T.I. No.: 2021-02 Updated: -	Topic: Schaerer Barista - Software-Version 2.4.2
---	---

Date: 16.02.2021	Priority	Need for action
Affected machines: Schaerer Barista	High	As soon as possible
From serial number: -	X Medium	X On next visit to the machine
As of date: immediately	Low	FYI

Antifreeze protection / transport preparation

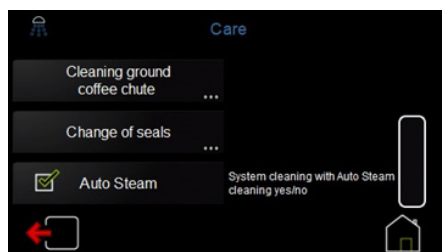
In order to prepare machines that have already been put into operation for transport to another location freeze-proof, an emptying routine has been implemented. This routine is completely display-guided and can only be started when the machine is heated up. As the routine also empties the machine backwards in the direction of the water supply, it is important to disconnect the machine from the water supply - AFTER DISPLAY PROMPT.

After completion of the routine, the machine switches off. In order to make the machine freeze-proof, the steam boiler was emptied by approx. 90% and the steam and coffee paths were blown free via the air pump.

If the machine is switched on again, the system is refilled.

2nd Auto Steam and foam pre-selection

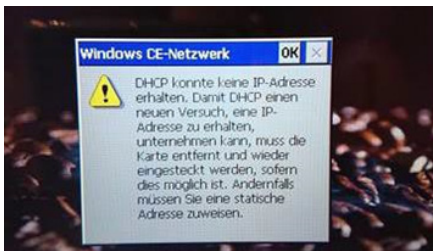
After the feature "Auto Steam pre-selection for machines with two Auto Steam wands" was introduced with software version 2.3.1, we received reports of machines that rebooted during the automatic start of the pre-selected Auto Steam. This error behaviour only occurred when the right Auto Steam was started first and the left Auto Steam waited in the preselection and then started.

The error has been corrected with this software version.
